TECHNICAL BULLETIN INDEX
Sorted by Bulletin Number
06/25/86

DATE: January 10, 1983
REVISION DATE: January 10, 1983
BULLETIN NO.: 12/16B:1
PRODUCT: 26-4004/5 (Model 12)
SUBASSEMBLY: Motorola Video Board

PURPOSE: To explain the differences between Motorola driver board used in the Model 16 and the version used in the Model 12.

Figure 1

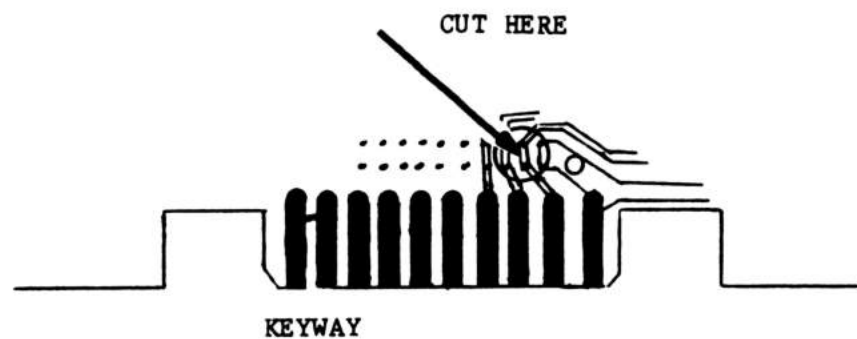
DISCUSSION: The Model 16 can use either an unmodified or modified Motorola video board, although it comes with an unmodified board. The Model 12 must use a video board that has been modified with a cut and jumper. This modification allows the video signal from the video/keyboard interface board to be routed through the video driver board on its way to the brightness control. This modification must be done to any Motorola board that is used in a Model 12.

PROCEDURE: The modification consists of a jumper that connects pin 2 of P1 to pin 5 placed in the holes closer to the edge connector as shown in figure 1. Then a cut must be made between the 2 holes in the trace that is connected to pin 2 which will disconnect pin 2 from the rest of the PC board as shown in figure 2.

Figure 2:

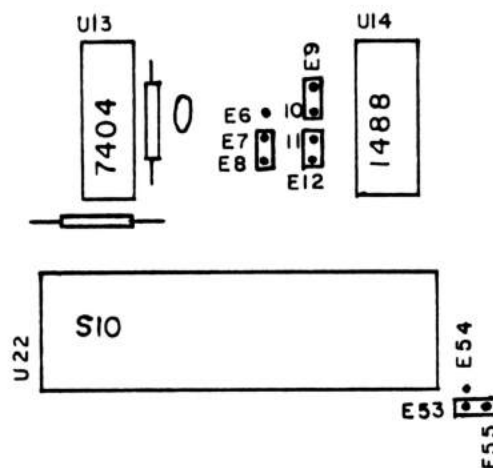
Remove jumpers E10-E11 and E53-E54 and install jumpers E53-E55, E9-E10, and E11-E12 as shown on page 4 in figure 2. You will need an additional jumper, National Parts part number AJ-6769 jumper plug. If these are not in stock wire wrap can be used instead.

If it is going to be used with a modem the main logic board should be modified as shown in figure 3 by removing E10-E9. If it is going to be wired directly to another computer it should be left as in figure 2. Also, it is recommended that the customer use a 12 conductor cable on their serial channel instead of a 25 conductor cable.

Loopback connector modifications

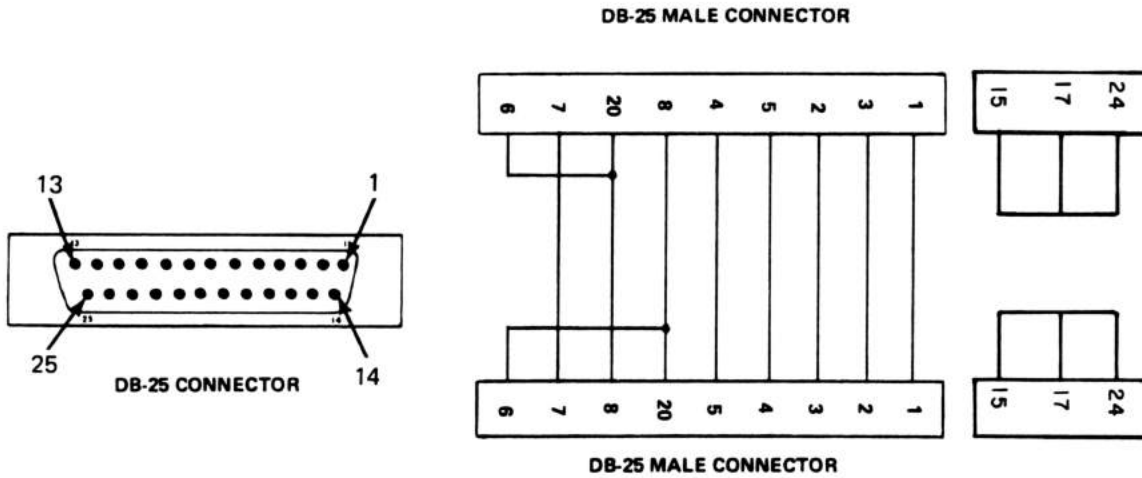
The loopback connector used with AUTO3 should be modified as shown on page 5. The connector will then be usable on both BISYNC and async computers. Run AUTO3 or the Model II family System Test on the modified computer with the modified loopback connector to verify the hardware and jumpers.

Schematic changes

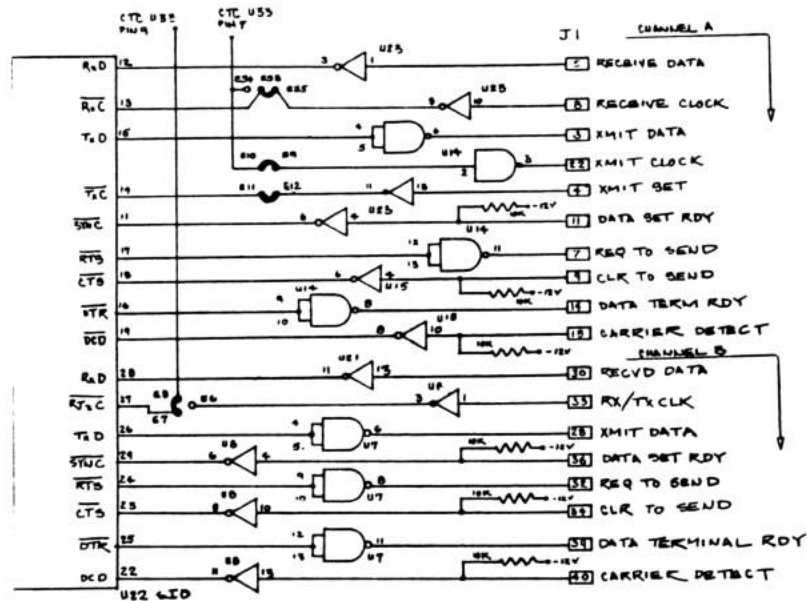
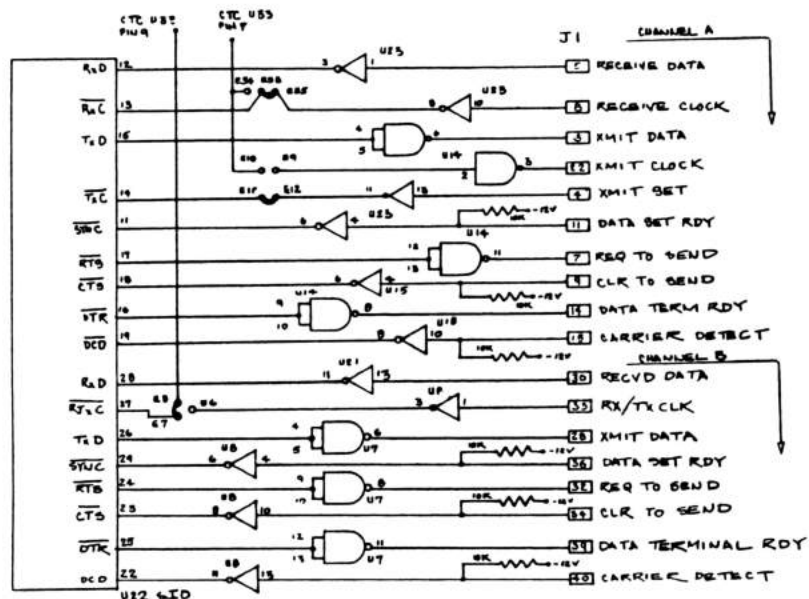
Looking at the schematic on page 6, the new jumper positions take the transmit clock for channel A and connects it to pin 24 of the DB25 for channel A. This breaks the connection between the transmit clock and the SIO chip. The transmit clock will now be provided by the modem through pin 15 of the DB25 connector (I/O XMIT S.E.T.). The clock for the receive section of SIO channel A now comes from pin 17 of the DB25. This means that we are now using two sections of U23 and one section of U14 that have been previously unused.

Figure 1

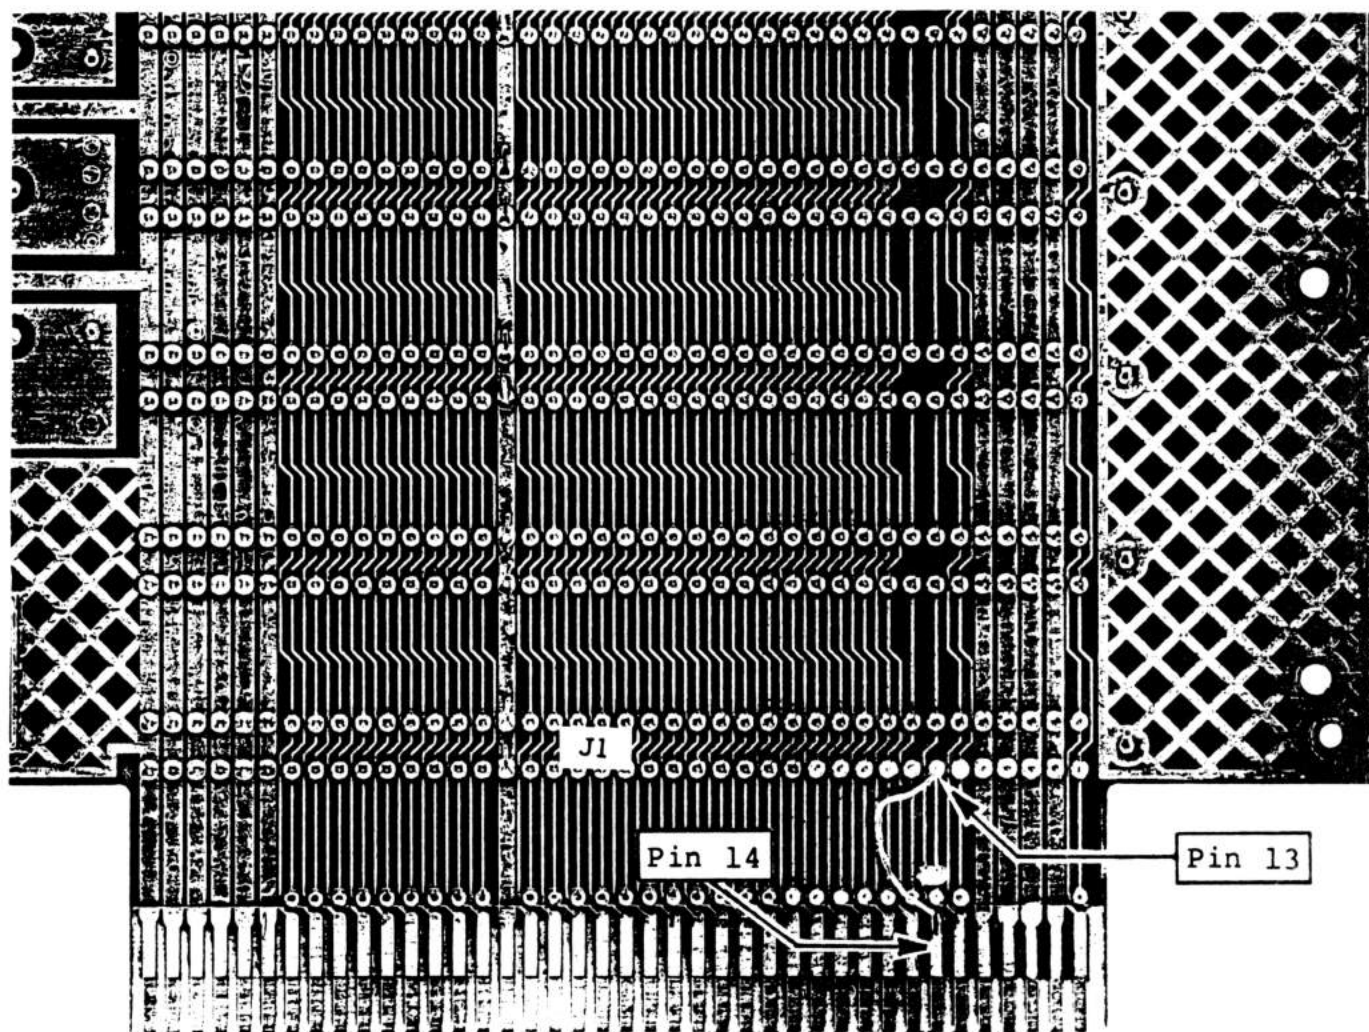
DISCUSSION: An error in the artwork of the mother board (revision PP4), will cause the 1st slot of the mother board to not function properly when a board using Z-80 family interrupts is installed.

PROCEDURE: Just above the point where the mother board plugs into the main logic board cut the two traces going to pins 13 and 14 of the plug (figure 1). Then run a jumper from pin 14 of the plug that goes into the mother board to pin 13 of the first socket in the mother board (J1).

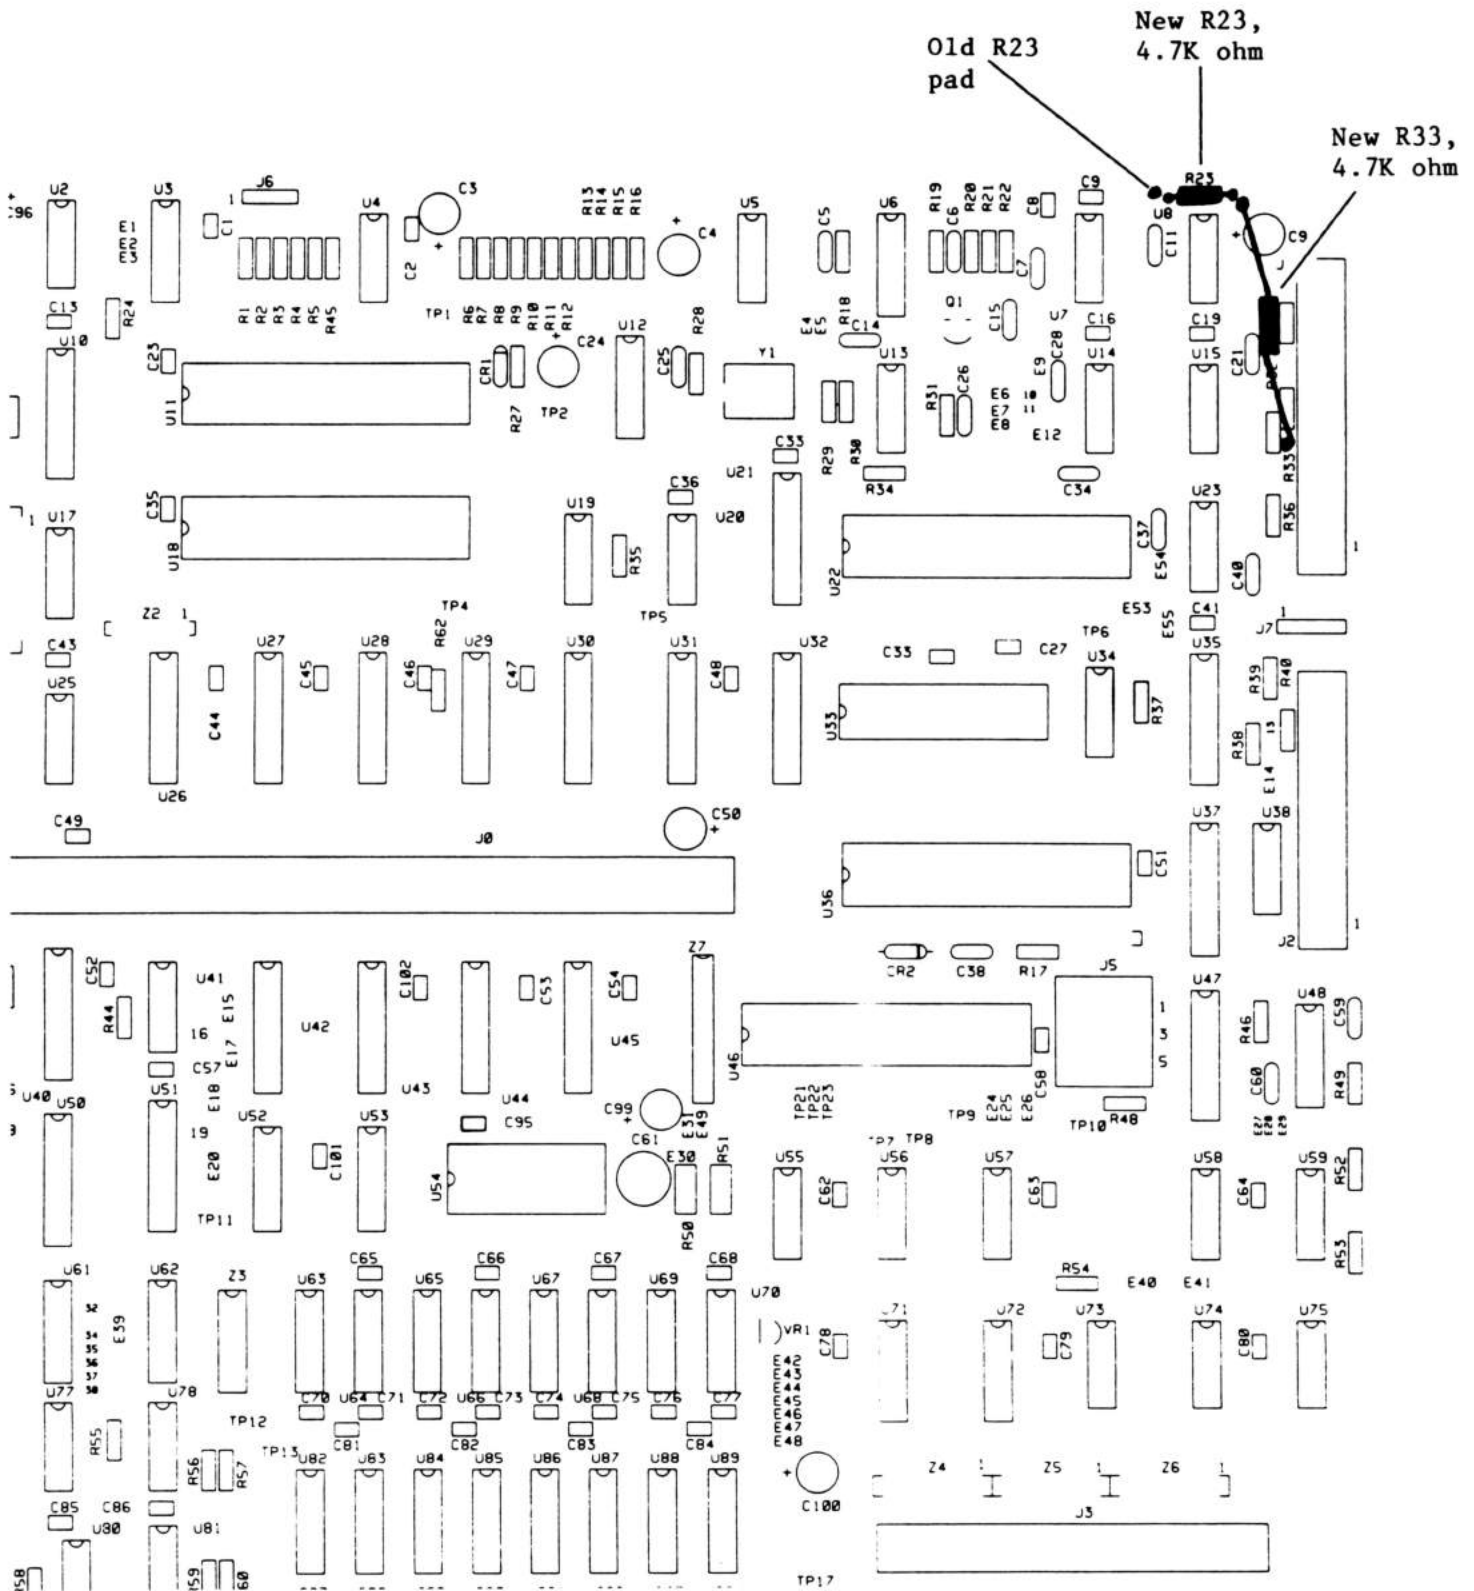
Change R21, R23, R25, R32, R36 from 10K ohm to 4.7K ohm resistors. Remove resistor R33. On the component side of the board, install a 4.7K ohm resistor with one lead attached to the old R33 solder connection closest to R36 and the other lead attached to the +12V line at the feedthrough adjacent to R23 between U8 and C97 (refer to figure 1). The leads should be insulated to prevent them from shorting.

Remove resistor R23. On the component side of the board, install a 4.7K ohm resistor with one lead attached to the old R23 solder connection closest to C97, and the other lead attached to the +12V line at the feedthrough adjacent to the remaining R23 solder connection. The +12V line in question also connects directly to U7, pin 14 (refer to figure 1).

Figure 1 Video PCB (component side)

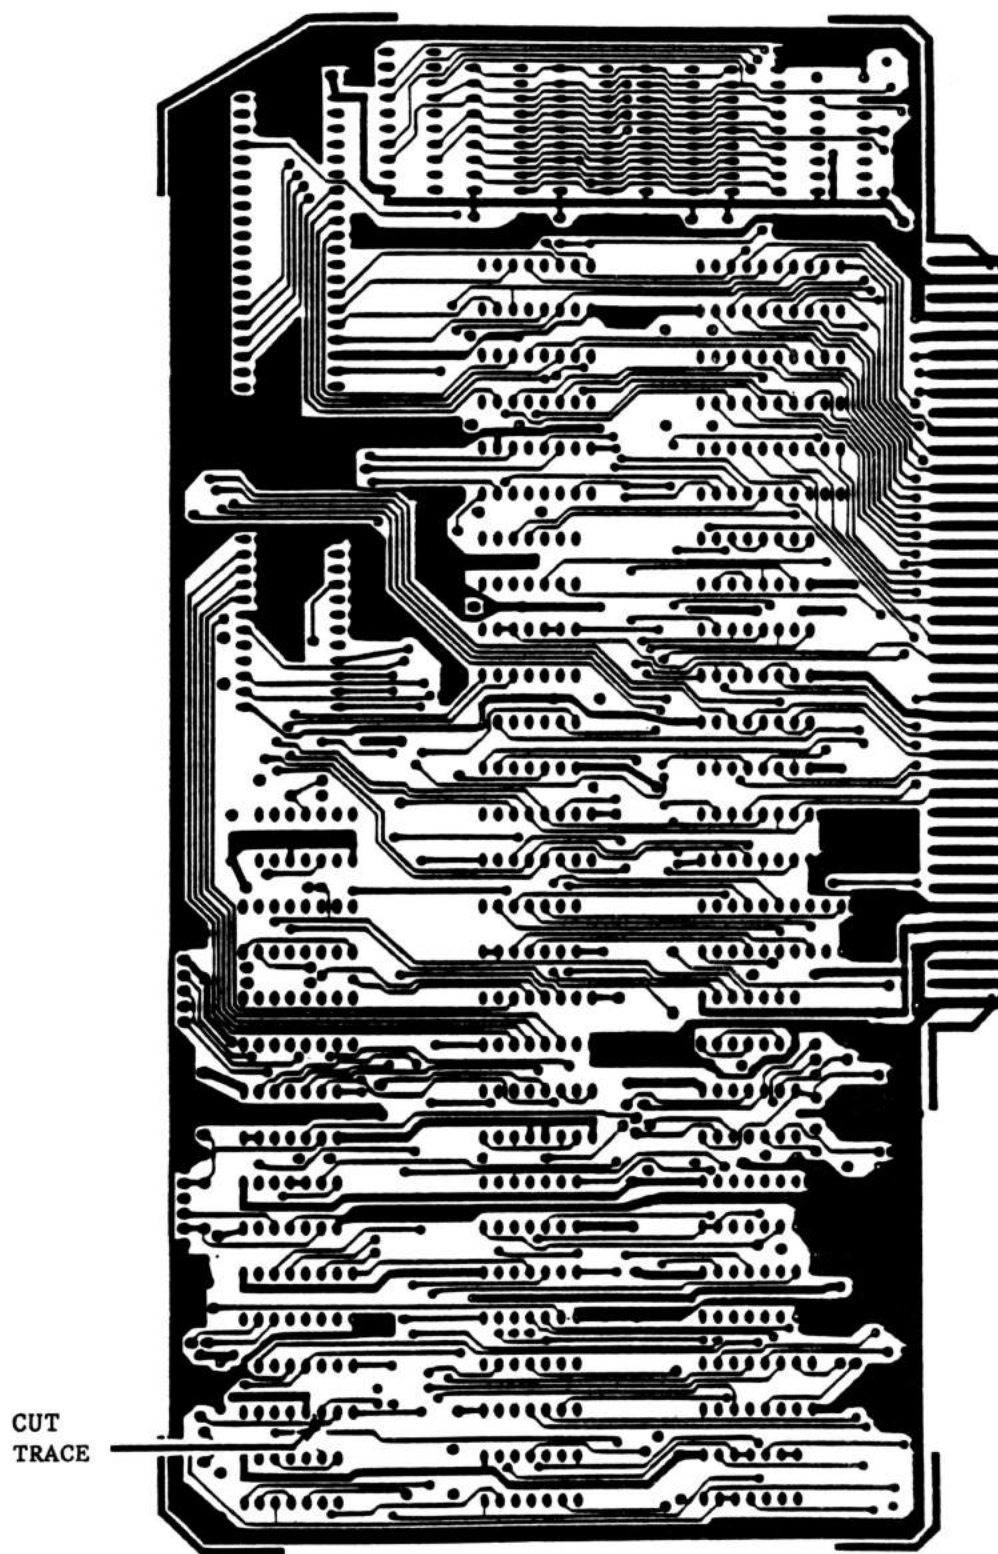
High memory addresses are shared by the Video and the 64K RAM. When the computer needs to use the video, it will activate the video RAM select logic allowing access to it. Occasionally when doing very fast RAM switching such as diagnostics, due to the access time specification of the RAM, the data transfer may not be reliable causing video failures. To correct this change the video select timing from 10ns to 100ns.

Refer to Figure 1 and cut the trace on the component side at U32 pin 7. Add a jumper wire from U32 pin 7 to U32 pin 12.

Figure 1

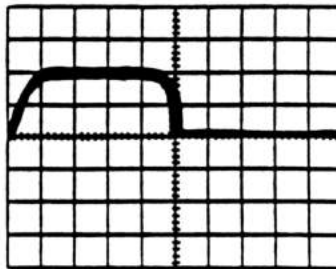
5. Connect the scope probe to TP10 and adjust R50 to attain a positive pulse-width of 200ns. Refer to Figure 1.
6. Connect the scope probe to TP8 and adjust R51 to attain a positive pulse-width of 500ns. Refer to Figure 2.
7. After these three adjustments have been done, replace jumper E30-E31 back to its original position, E31-E49.
8. Perform a system RESET then insert a Floppy Disk and proceed with diagnostic check-out.

Figure 1

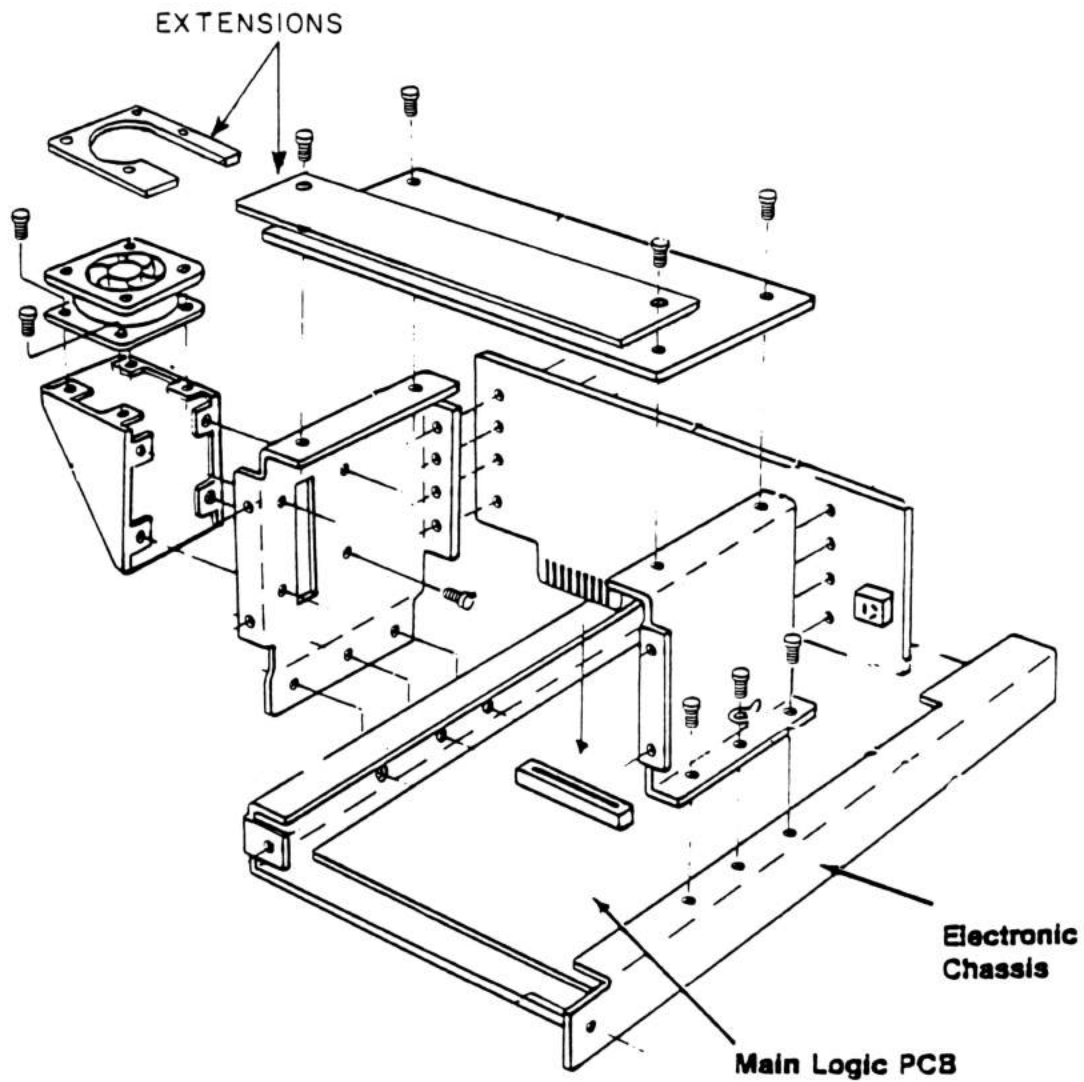
Refer to Figure 1 for the remaining steps.

2. Remove the 6 screws that hold the card cage to the chassis.
Disconnecting the motherboard power plug and the fan wires will allow the card cage assembly to be pulled up and removed.
 3. Remove the top plate, fan flume, and motherboard.
 4. Replace the left and right side plates with the corresponding part numbers listed above.
 5. Reassemble the card cage and the computer and check for proper operation.
-
